STATE OF FLORIDA
DEPARTMENT OF HEALTH
ONSITE SEWAGE TREATMENT AND DISPOSAL
SYSTEM
APPLICATION FOR CONSTRUCTION PERMIT

STATE OF FLORIDA
DEPARTMENT OF HEALTH
ONSITE SEWAGE TREATMENT AND DISPOSAL SYSTEM
EXISTING SYSTEM AND SYSTEM REPAIR EVALUATION

From: Harris, Todd S
Sent: Thursday, May 31, 2018 2:26 PM
To: 'flsepticsolutions@yahoo.com'
Subject: 05-312-18 Lot 7 TH E

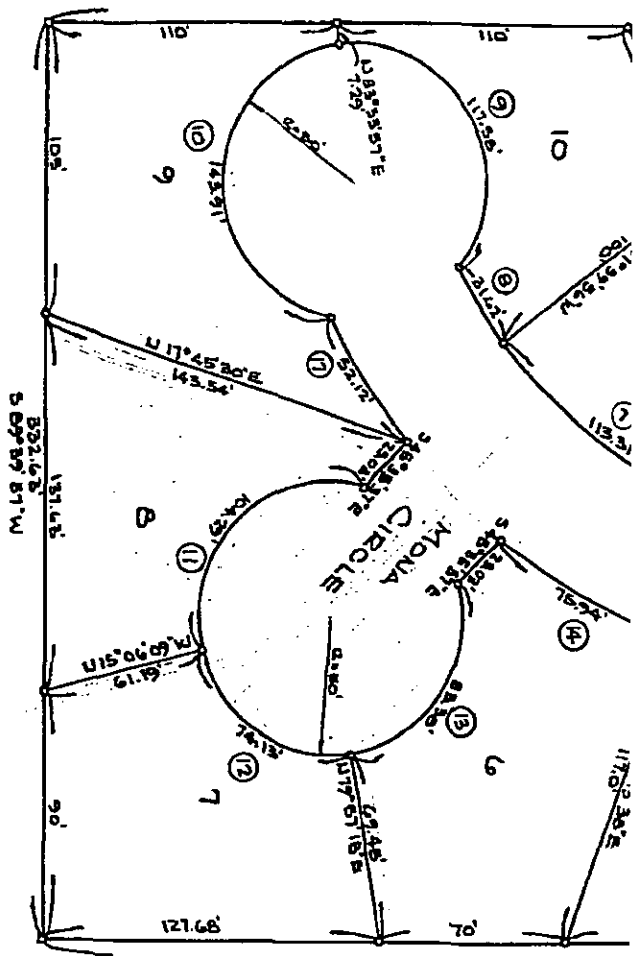
- Existing drainfield amount is 405 ft² from repair 4 years ago
 - Revise 4015 and associated calcs
 - Is age still a cause of system failure?
- Existing drainfield location not shown on site plan
- Driveway and parking area not shown on site plan
- ~~Soil profiles should be done over proposed drainfield area~~
 - Appears should be Table VII based on the soil texture *NA*
 - Installing in bed as Table VII will require greater area than indicated *NA*
 - Can the df fit in this area? House is angled and a lot bigger than indicated on plan
 - Appears there should be a 45" ESHWT based on description and mottling(?) but listed as 72

Revised 6/1/18

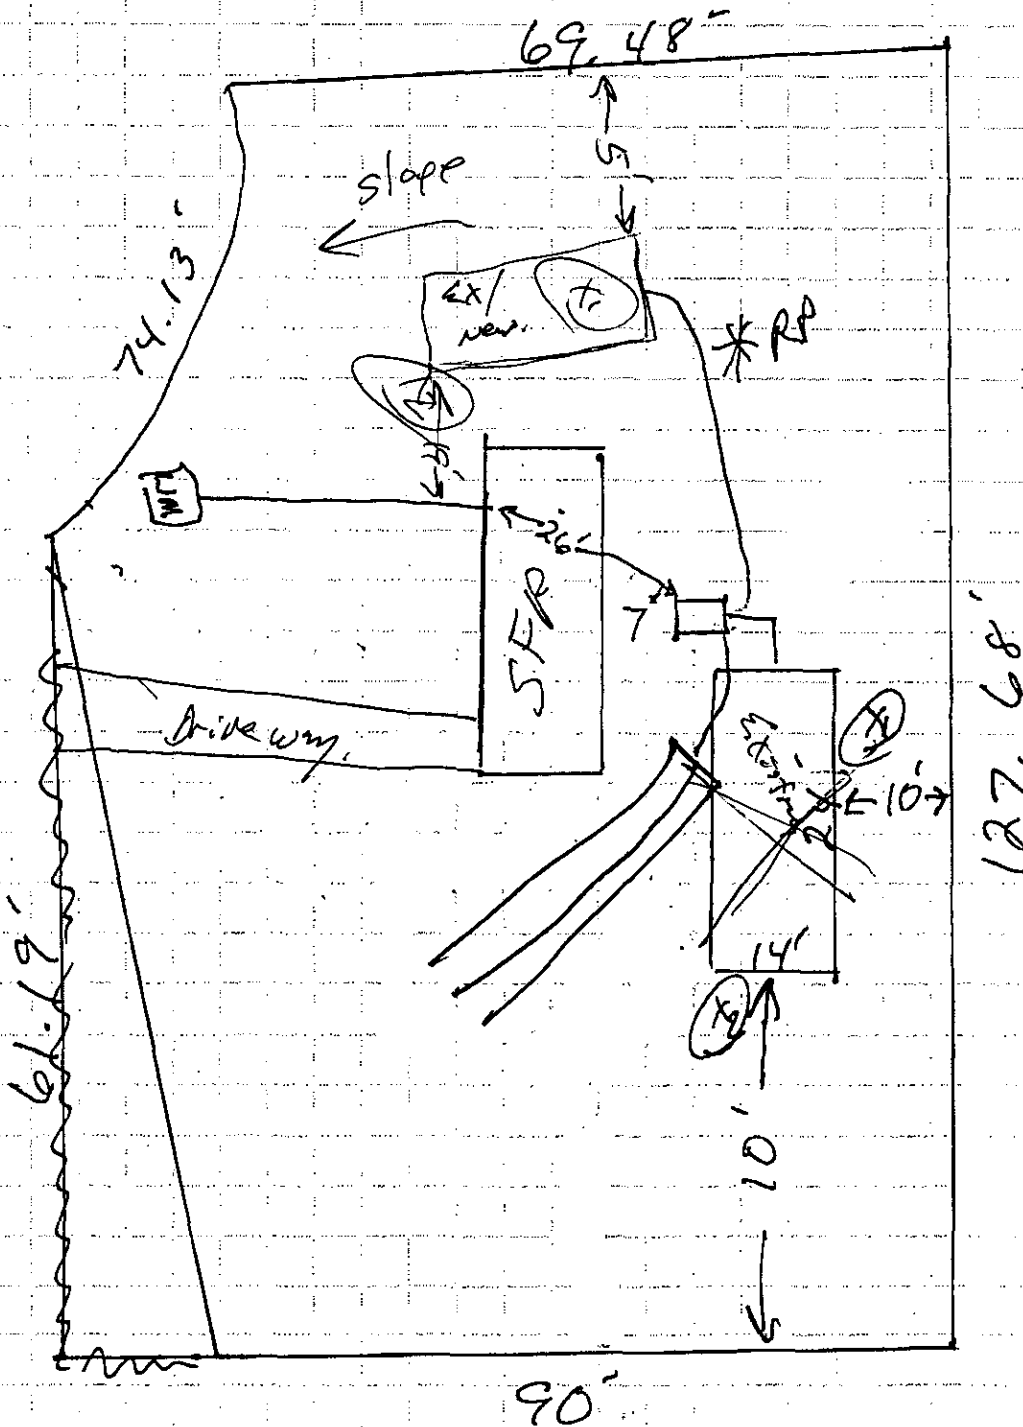
- Existing drainfield amount is 405 ft² from repair 4 years ago
 - Revise 4015 and associated calcs
 - Is age still a cause of system failure?
- Existing drainfield location not shown on site plan
- Driveway and parking area not shown on site plan
- ~~Soil profiles~~ should be done over proposed drainfield area
 - Appears should be Table VII based on the soil texture *NA*
 - Installing in bed as Table VII will require greater area than indicated *NA*
 - Can the df fit in this area? House is angled and a lot bigger than indicated on plan
 - Appears there should be a 45" ESHWT based on description and mottling(?) but listed as 72
